Valley View Village - 2571 Guthrie Avenue

ZON2007-00142

Communication from the City Plan and Zoning Commission advising that at their meeting held September 20, 2007, the following action was taken:

(2) EXTERIOR ELEVATIONS
(A3) NO SCALE

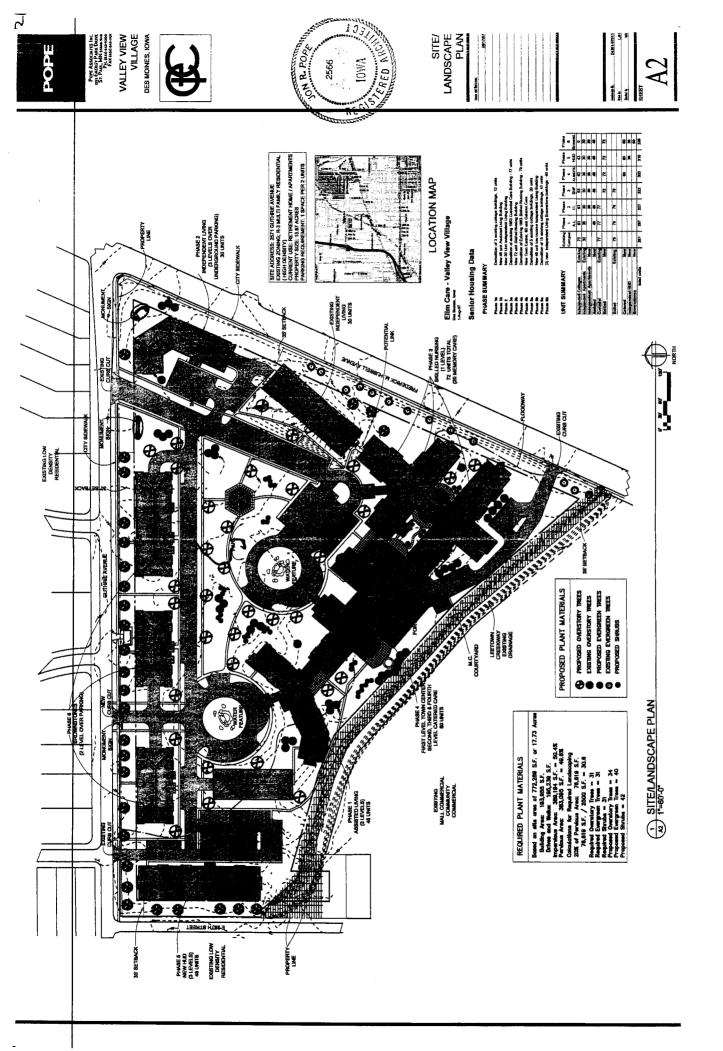
- 7. 2020 Community Character Plan: The proposed 338 dwelling units on 17.73 acres represents a density of 18.95 units per acre, which is in conformance with the High-Density Residential land use designation.
- 8. Urban Design: The submitted elevations indicate that all structures would have a common architectural theme. According to the submitted renderings and narrative, at least 15% of all facades would be stone and/or rock-faced block. The remainder will be hard surface material such as brick, stucco, and cement board siding. Roofing would be a profile (architectural) shingle of a color to complement the stone. Staff recommends that the notes provided in the narrative regarding construction materials be transferred to the Concept Plan.

The elevations indicate that significant articulation of the structures would be achieved through variation of rooflines, setbacks, patterns of door and window placement, and the use of characteristic entry features. The elevations also indicate that structures would have multiple gables to break up expansive roof plains.

The proposed Concept Plan does not indicate fencing would be permitted on the site. Staff recommends that a note be added to state that any fencing on the site be in accordance with the regulations as applicable to the "R-3" District and that any chain link fence shall be clad with black vinyl.

Staff recommends that a note be added to the Concept Plan stating that any dumpster enclosure shall be constructed with masonry materials to match the proposed structures.

- 7. Provision of a sidewalk along East 25th Street.
- 8. Provision of sidewalk connections from all buildings to the sidewalks along public streets.
- 9. Provision of a statement that at least 15% of the facade would be stone and/or masonry materials, with the remainder being hard surface material such as stucco or hardi-plank siding.

- 10. Provision of a statement that all roofing material shall be architectural-type shingles of a color to complement the stone or masonry materials.

- 11. Provision of a statement that any fencing on the site be in accordance with the regulations as applicable to the "R-3" District and that any chain link fence shall be clad with black vinyl.
- 12. Provision of a statement that any dumpster enclosure shall be constructed with masonry materials to match the proposed structures.

CORNER SIGN ELEVATIONS

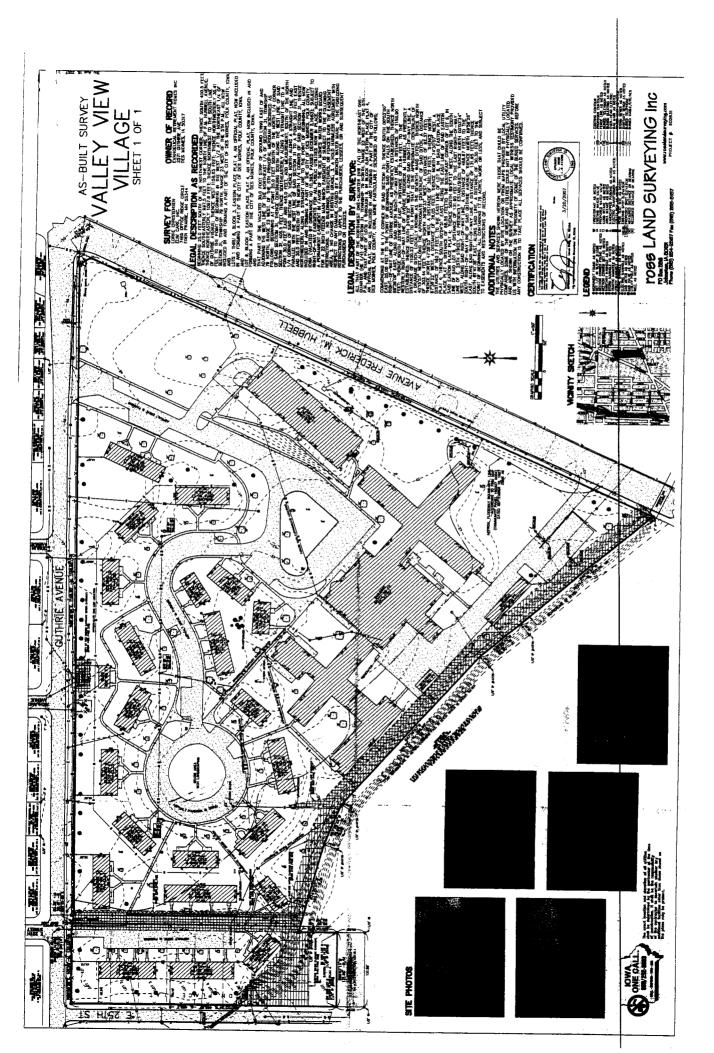
The proposed Concept Plan indicates that two monument signs would be located near entrances from Guthrie Avenue. These decorative signs would be constructed of stone and masonry materials to complement the proposed structures and include planters. An additional sign constructed of stone would face the intersection of Hubbell Avenue and Guthrie Avenue.
